Springfield-Beckley Municipal Airport

Advisory Committee Meeting
Springfield-Beckley Municipal Airport
Master Plan Update

RE | Analysis of New ATCT Site

Selected ATCT

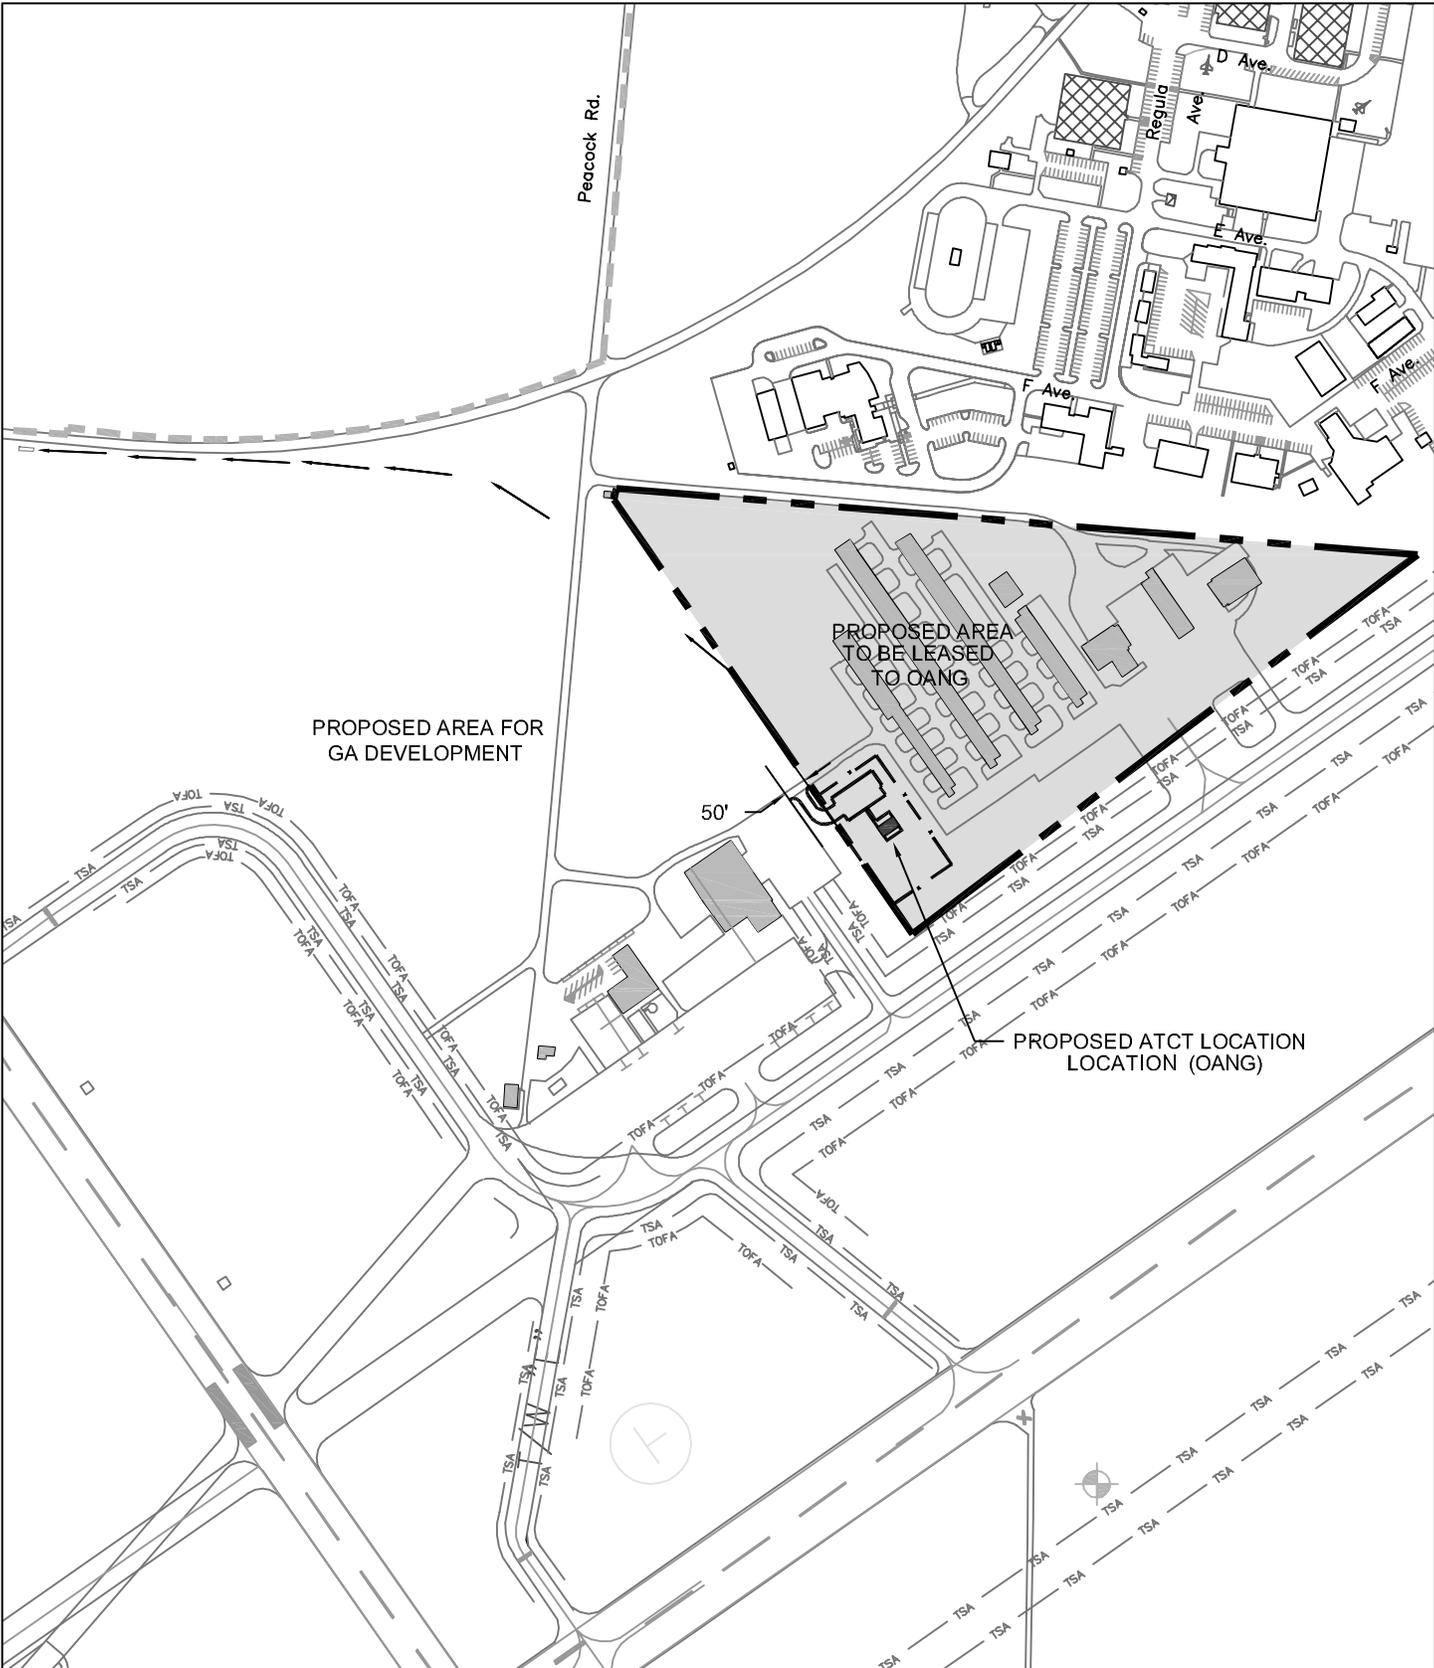
In December 2003, subsequent to their *June 20, 2001 Statement of Intent for Proposed Construction of New Control Tower at Springfield ANGB, Ohio*, the Springfield Ohio Air National Guard (OANG) identified an additional preferred airport traffic control tower (ATCT) location. This location is between the existing t-hangars and fixed base operator apron, as shown on **Exhibit 1**.

The new ATCT line-of-sight has been reviewed from a general aviation development perspective. The most restrictive line-of-sight is to the ground of the Taxiway F safety area and to the approach to Runway 15. Although the facility requirements analysis of the master plan did not recommend a precision approach to Runway 15, to allow maximum flexibility for the

EXHIBIT 2
Line of Sight
No Changes to Taxiway F

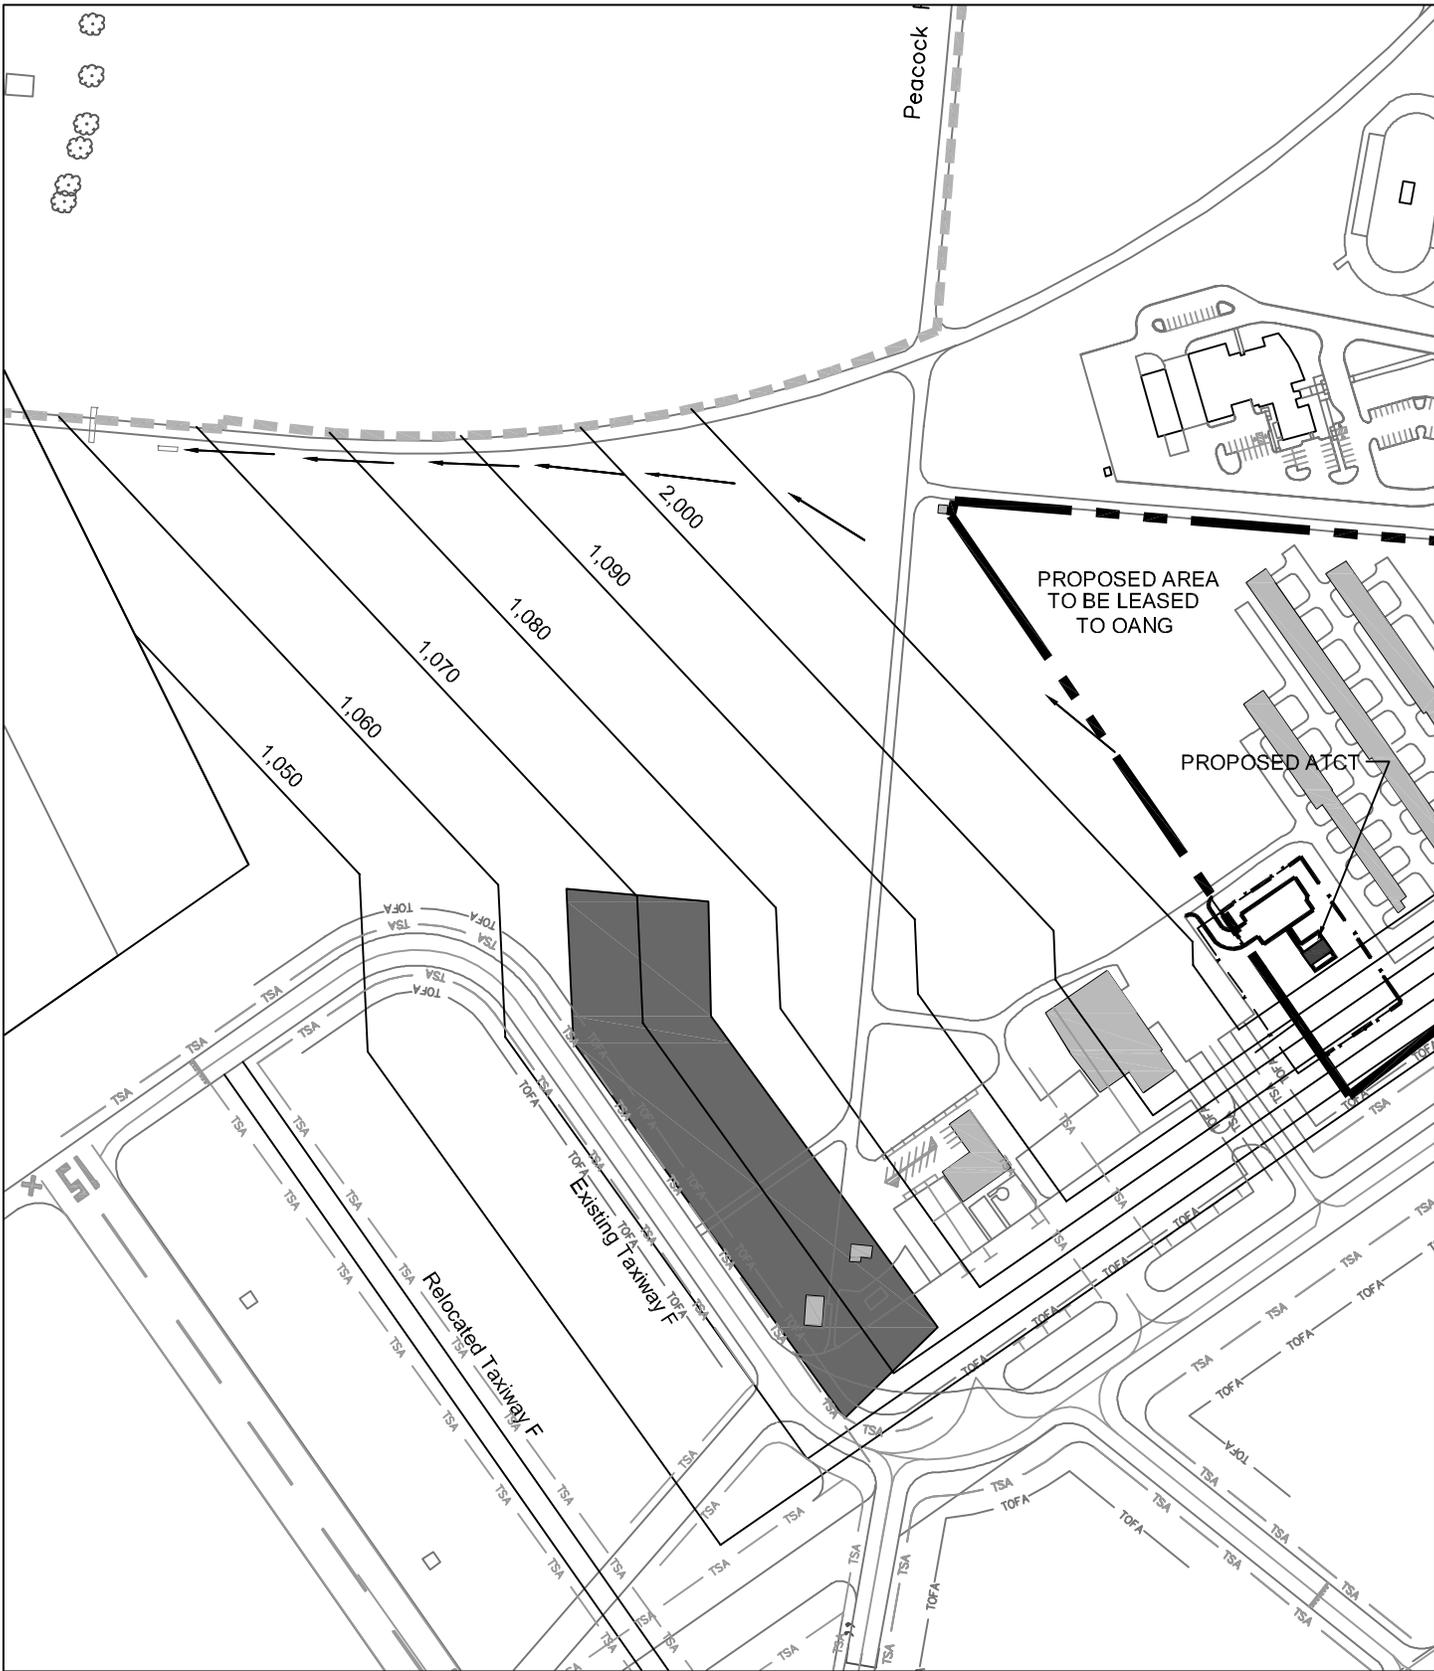
Exhibit 2 shows the allowable height for objects, buildings or aircraft tails, in the general aviation expansion area with Taxiway F in its present location. However, Taxiway F could also be relocated from its existing 725-foot centerline to centerline separation from Runway 15-33 to 300-foot centerline to centerline separation. As shown on **Exhibit 3**, this opens up approximately four acres of additional development area with usable allowable height (20 feet or more). This increase is less than when the ATCT was proposed north of the existing t-hangars because more of the allowable height is dictated by the need to see the approach, which does not change with the relocation of Taxiway F. Per the cost estimates in the draft Alternatives Analysis chapter, the relocation of Taxiway F is approximately \$1 million. With the new ATCT location, the relocation of Taxiway F to gain approximately four acres does not appear cost effective and will not be considered further.

EXHIBIT 4
Apron Areas

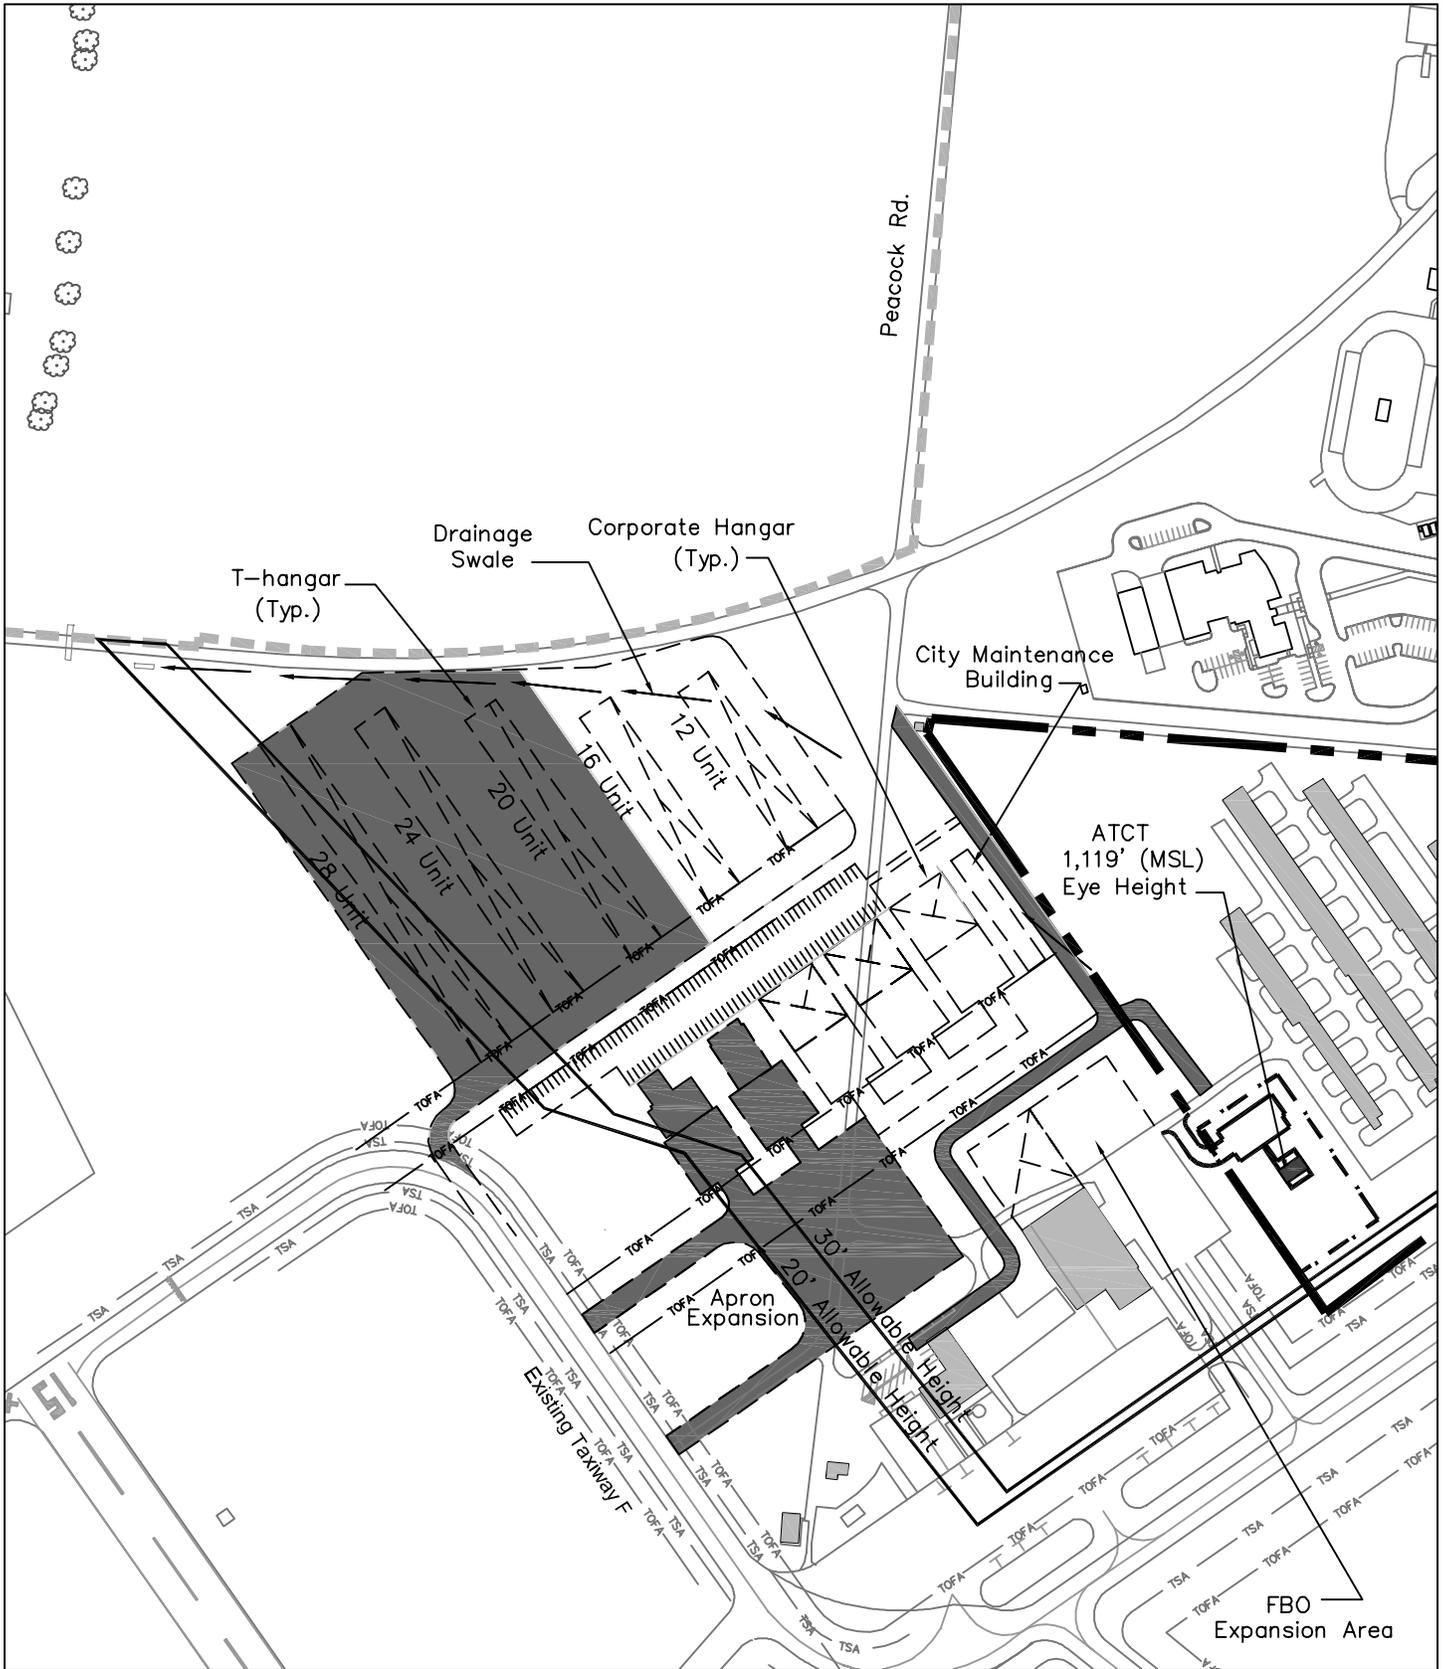
Another potential location identified for additional apron area is northwest of the terminal building as shown on **Exhibit 4**. This location would be associated with the replacement general aviation facilities. While this location could be sited to provide adequate allowable height, it would not be contiguous with the existing terminal apron and would not be readily visible from the existing terminal building.

The alternative of wrapping the terminal apron around the west side of the terminal building was also examined as shown in **Exhibit 4**. This location would keep all of the apron area contiguous. To use this area, the electrical vault and potentially the fuel facilities would need to be relocated. The OANG is planning to relocate their weather station that is in this area to the new ATCT site. However, adequate allowable height for parking ARC C-II corporate aircraft would only be available in this area with the relocation of Taxiway F to a 300-foot separation from Runway 15-33. Therefore, this location is not feasible in the foreseeable future.
